RE: 8500 Glendale Ave. NE
Revised Grading and Drainage Plan (For Pool Permit)
Engineer's Stamp Date: 12/04/20
Hydrology File: B20D067

RE File: B20D067, 8500 Glendale Ave. NE

TITLE: 8500 Glendale
Grading & Drainage Plan

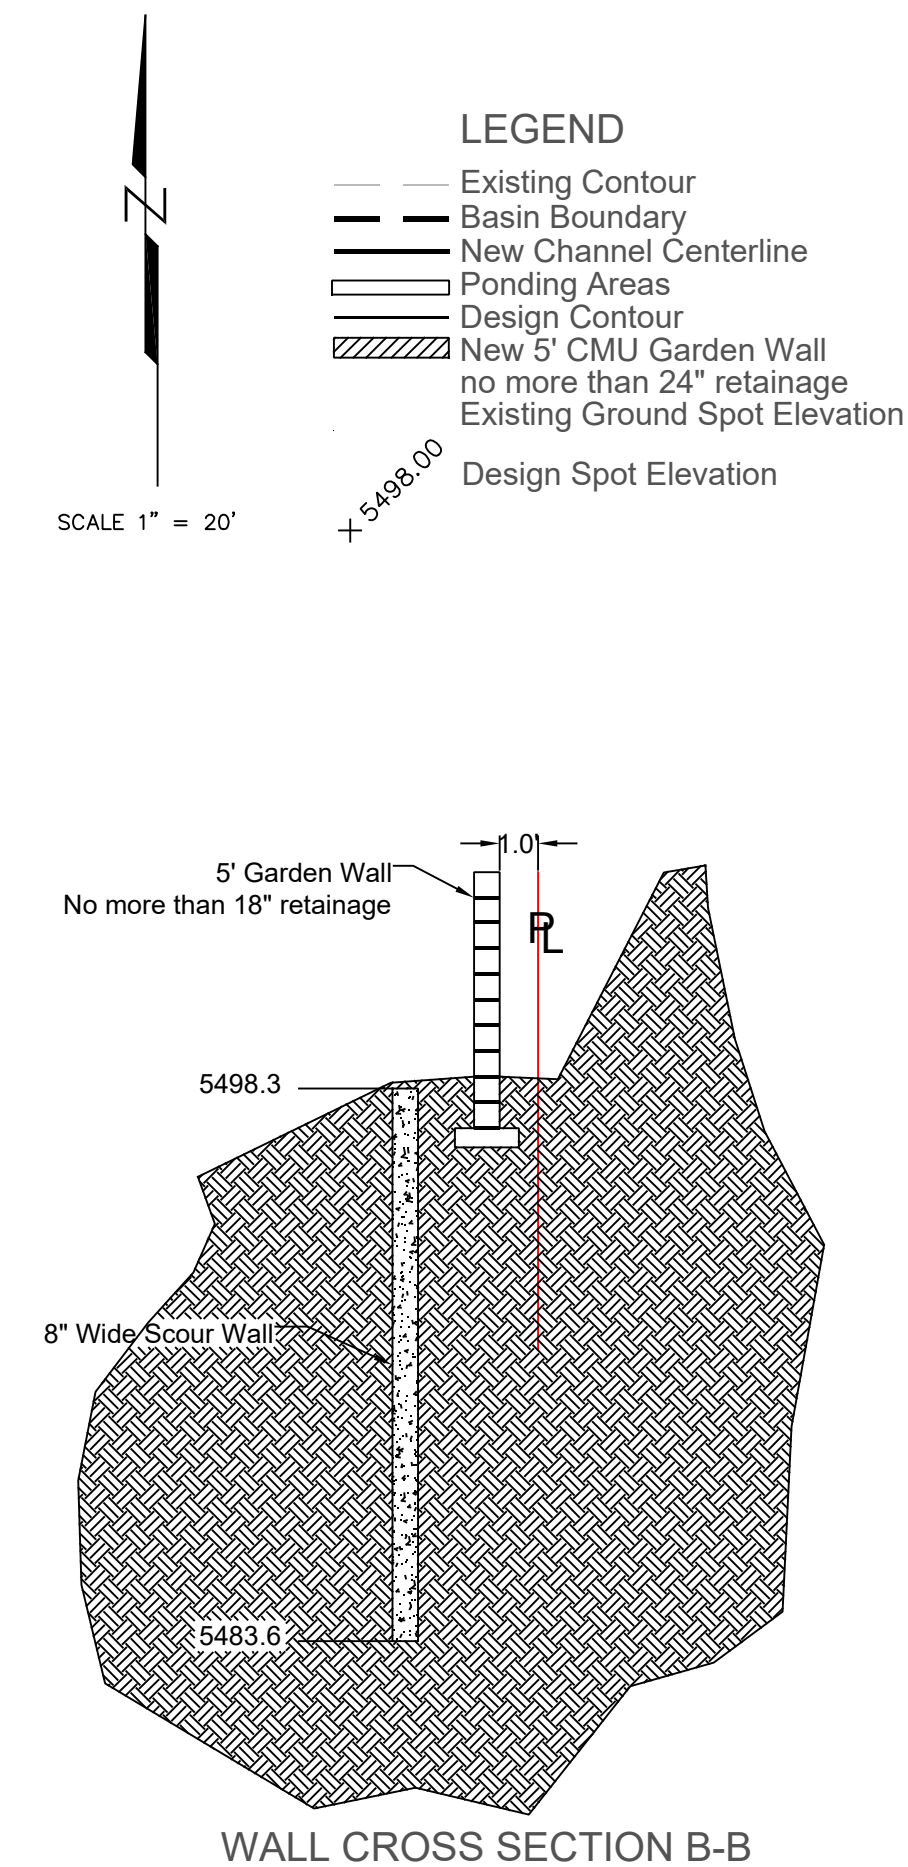
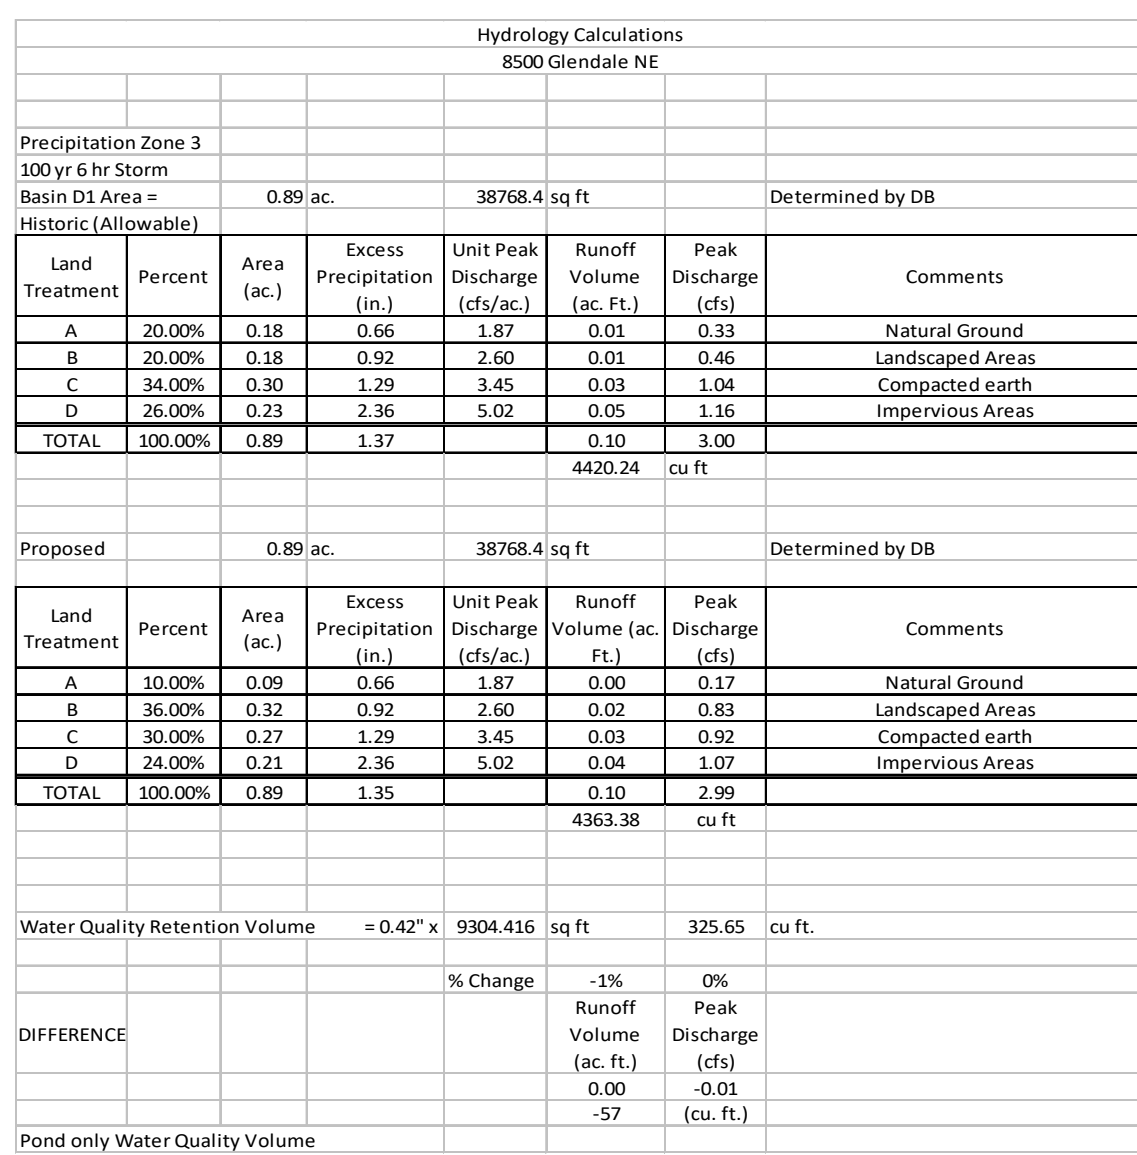
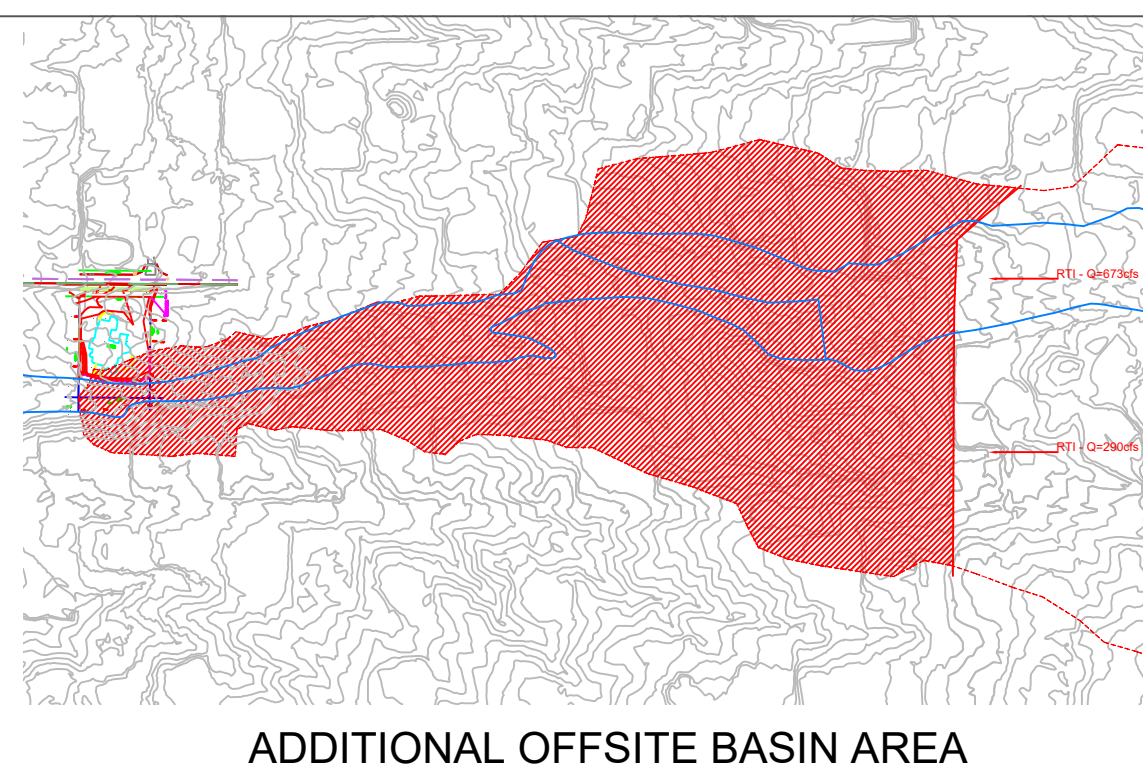
1. Please show the pool with concrete apron around the pool with grades of the corners of the pool. *This has been added to the plan.*
2. Please provide dimensions to all structures. *Dimensions have been added to the plan.*
3. I am concerned with the closeness of the pool with both the proposed garden wall and scour wall along the arroyo. Please provide a letter from either a geotechnical or structural engineer with supporting calculations stating that the pool does not pose any structural concerns with either the garden wall or scour wall. *Owner will provide this information.*
4. Please provide an updated engineer's stamp with the next submittal. *Provided.*
